REMARKS/ARGUMENTS

PROPOSED DRAWING AMENDMENTS
FOR SN 10/812,918

FIG. 1
(PRIOR ART)

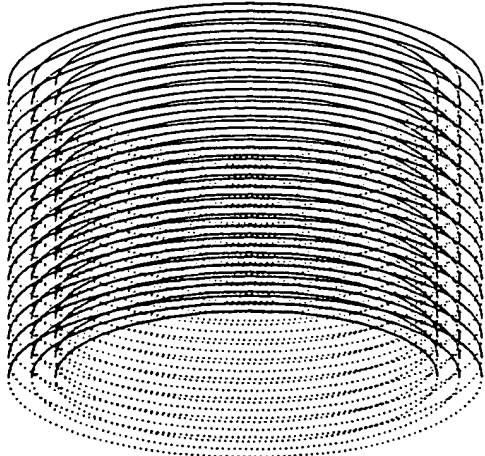
Proposed amendments adding “prior art” legends to Figures 1 and 2a in red ink are attached together with proposed new substitute drawings incorporating those changes.
